STAFF RECOMMENDATION
1729 4th Avenue North
November 19, 2014

Application: Demolition; New construction-infill
District: Salemtown Neighborhood Conservation Zoning Overlay
Council District: 19
Map and Parcel Number: 08205001700
Applicant: John Root, architect
Project Lead: Robin Zeigler, robin.zeigler@nashville.gov

<p>Description of Project: Application is to construct a duplex. Demolition for the non-contributing building was approved administratively.</p> <p>Recommendation Summary: Staff recommends approval of the project with the following conditions:</p> <ol style="list-style-type: none"> 1. The height be lowered by ten inches (10"); 2. Staff approve the windows and doors, shingle color, metal roof color, trim, fence, and rear porch materials; 3. The HVAC units be located on the rear façade, or on a side façade beyond the midpoint of the house; 4. All paired windows have a 4" to 6" mullion; and, 5. The finished floor height shall be consistent with the finished floor heights of the adjacent historic houses, to be verified by MHZC staff in the field. <p>With these conditions, staff finds that the project meets Section III of the <i>Salemtown Neighborhood Conservation Zoning Ove

FRONT ELEVATION

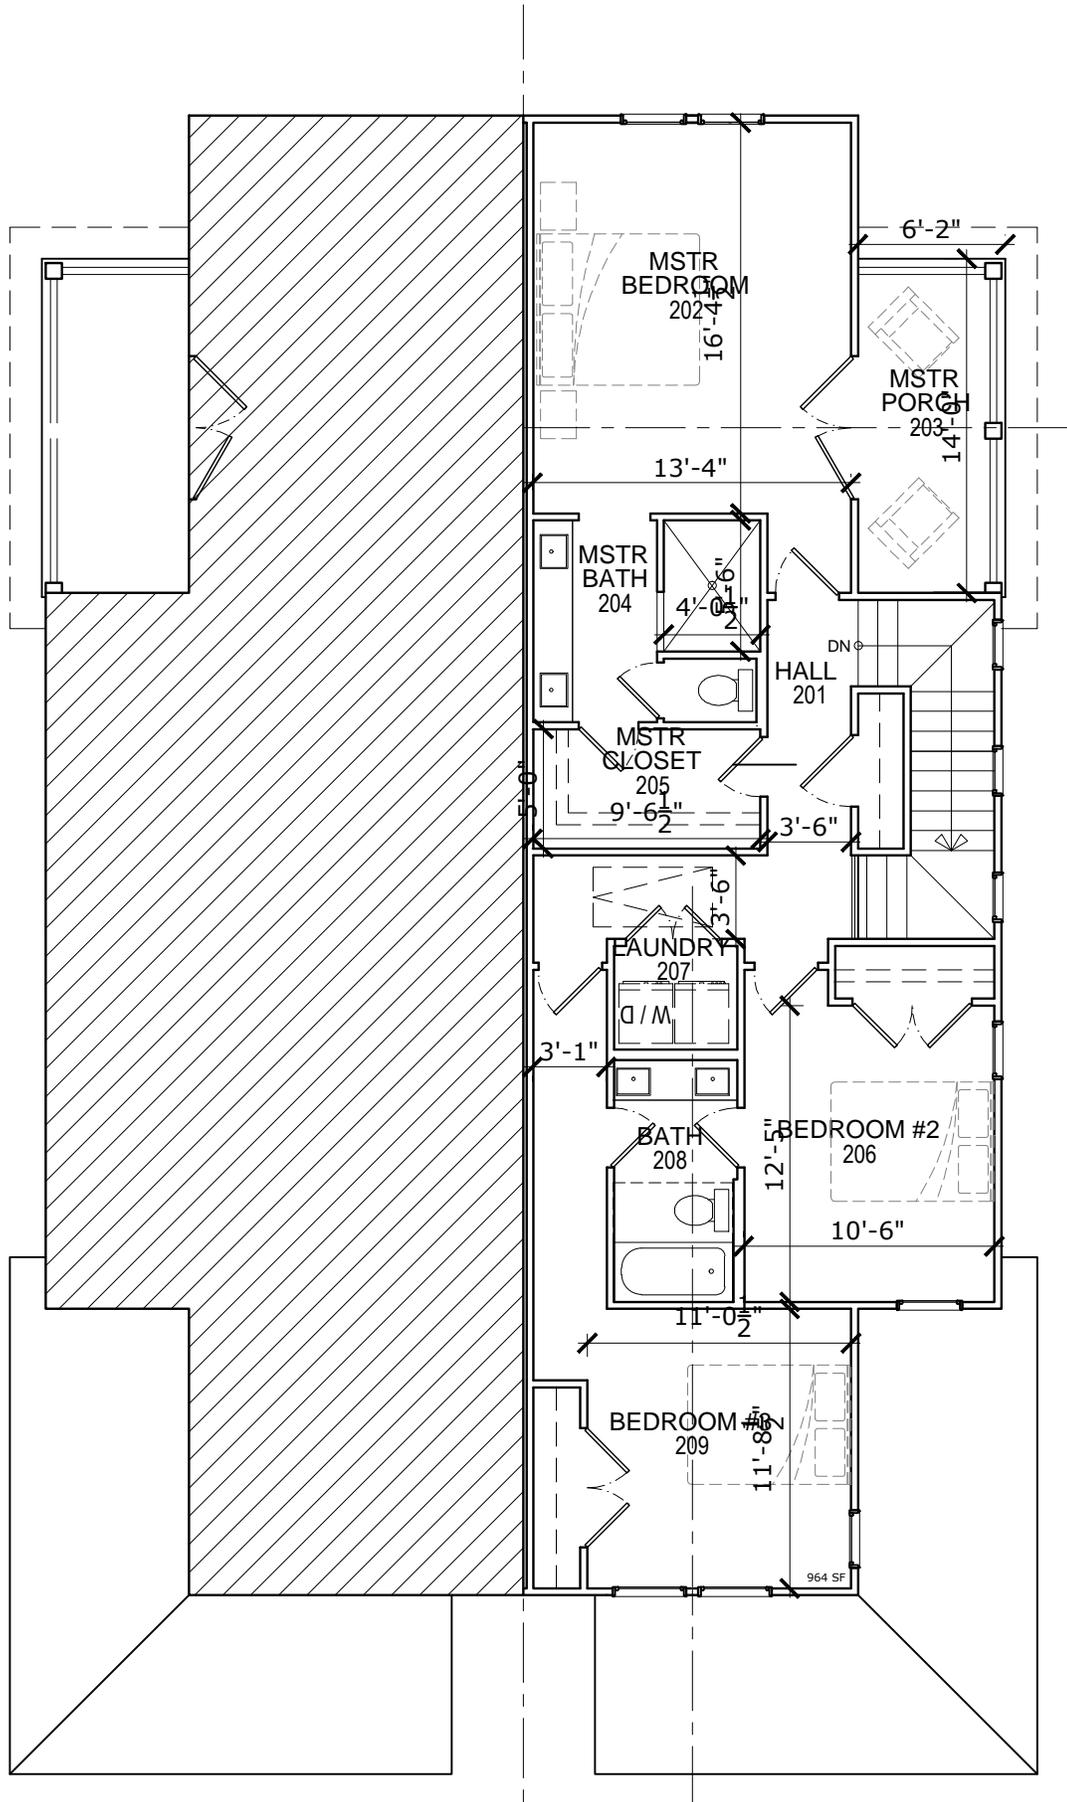
The foundation height will be approximately two feet (2') at the front. The porch eave height will be approximately nine feet (9') from the porch floor and the eave height for the house will be approximately twenty feet (20'). The ridge height is thirty-four feet and ten inches (34' 10") above grade. The design guidelines allow for a maximum of thirty-four feet in height. Since this maximum is well over the historic context, staff recommends lowering the height by ten inches (10").

Roof form: The duplex has a cross-gable roof form with a front clip. The front facing projecting gable has a slope of 10/12. The cross gable has a slope of 8/12. The front porch roof has a 4/12 slope. Staff finds that the proposed roof forms and pitches match the historic context and meet section II.B.1.e. of the design guidelines.

Proportion and Rhythm of Openings: The windows on the proposed addition are generally twice as tall as they are wide, thereby meeting the historic proportions of openings. There are no large expanses without an opening. Staff recommends that all paired windows have a four to six inch (4"-6") mullion between them. With this condition, staff finds the project's proportion and rhythm of openings to meet Section II.B.1.g. of the design guidelines.

1. The height be lowered by ten inches (10”);
2. Staff approve the windows and doors, shingle color, metal roof color, trim, fence and rear porch materials;
3. The HVAC units be located on the rear façade, or on a side façade beyond the midpoint of the house;
4. All paired windows have a 4” to 6” mullion; and
5. The finished floor height shall be consistent with the finished floor heights of the adjacent historic houses, to be verified by MHZC staff in the field.

SITE PLAN

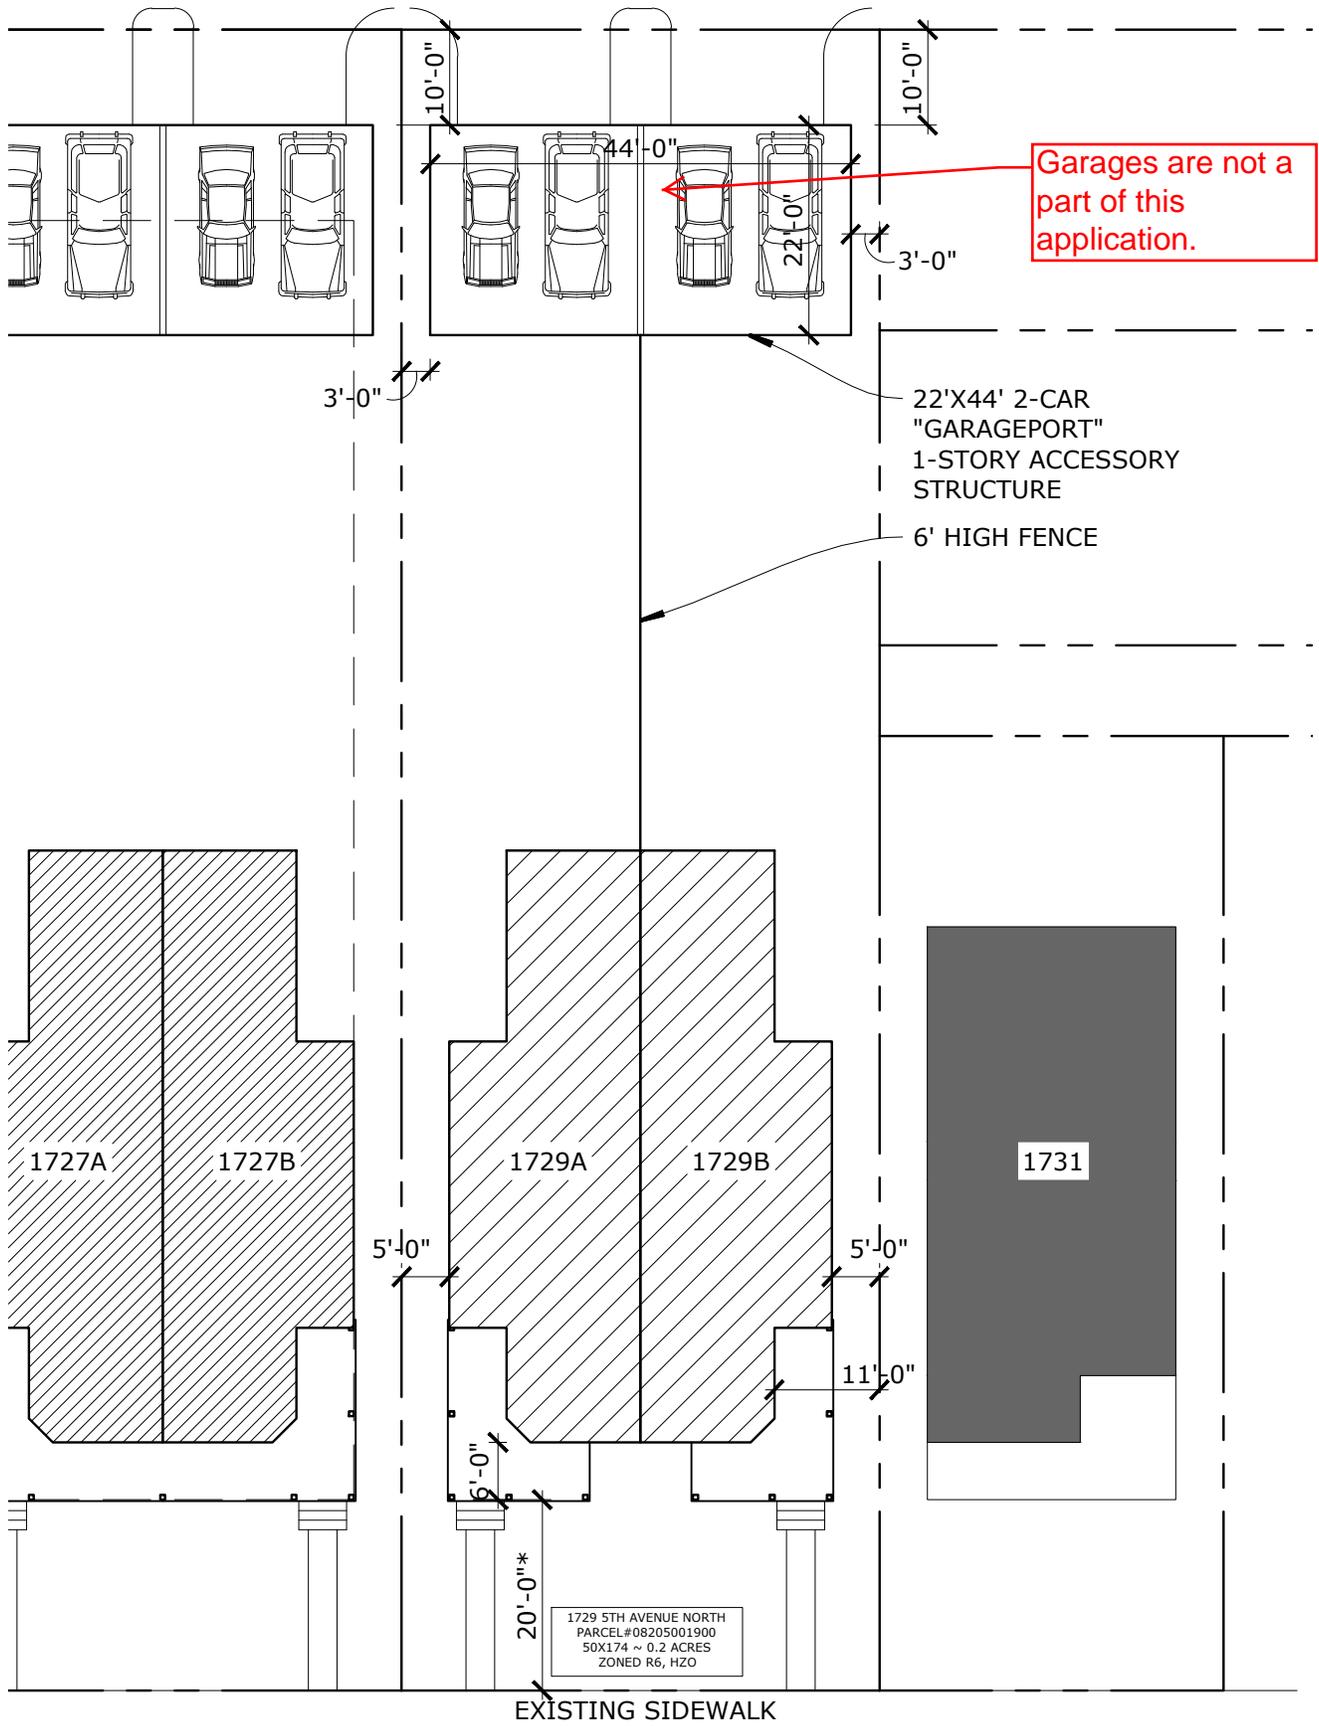
Setback & Rhythm of Spacing: The duplex will be centered on the lot, and meets all base zoning requirements for setbacks. It is a minimum of five feet (5') from each of the side property lines, and more than sixty feet (60') from the rear property line. The front setback matches the homes on either side. Staff finds that the duplex's setback and rhythm of spacing meet section II.B.1.c. of the design guidelines.

Appurtenances & Utilities: The location of the HVAC and other utilities was not noted. Staff asks that the HVAC units be located on the rear façade, or on a side façade beyond the midpoint of the house. A six foot (6') tall fence divides the rear yard.

Outbuildings: Although a four-bay garage or carport is shown on the site plan, no elevations were submitted. Staff has advised the applicant that a four-bay structure does not meet the design guidelines. Section II.B.1.h is not applicable at this time.
